## ***Interactive comment on “Multi-objective regionalisation for lake level simulation, the case of Lake Tana in the Upper Blue Nile, Ethiopia” by T. H. M. Rientjes et al.***

**T. H. M. Rientjes et al.**

### **Anonymous Referee #3**

Fig. 1.

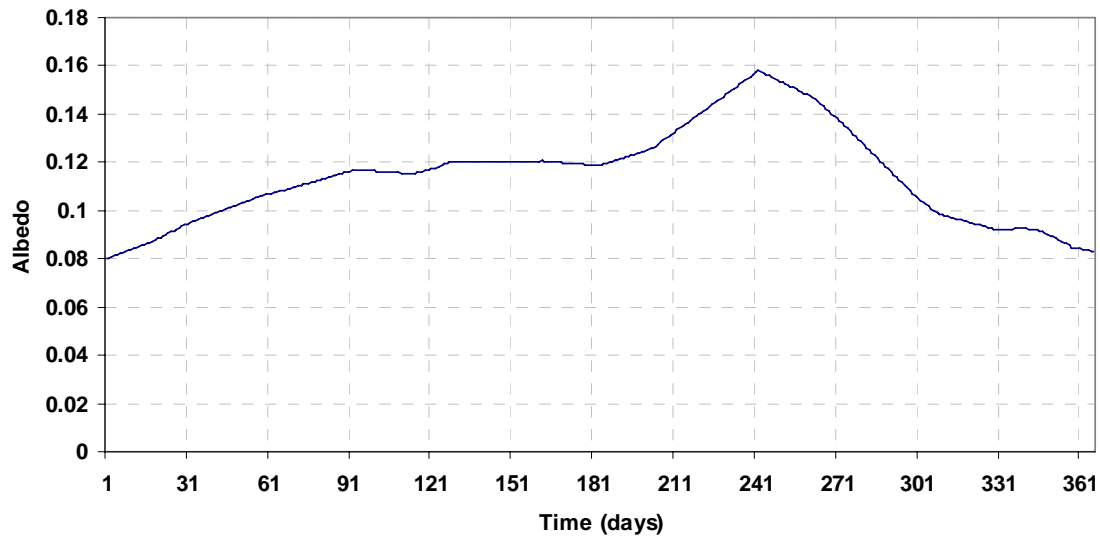
P. 7360, L 21; why albedo shows a big range for the water surface of Lake Tana? Any validation?

*Reply: We think the reviewer refers to page. Albedo may range between 0.03 and 0.1 when zenith angles are small and between 0.1 and 1.0 when zenith angles are large. In this case Albedo ranged from 0.08 to 0.016 during the year as shown in the attached figure. To our opinion values are not unrealistic. A small description has been added to the manuscript.*
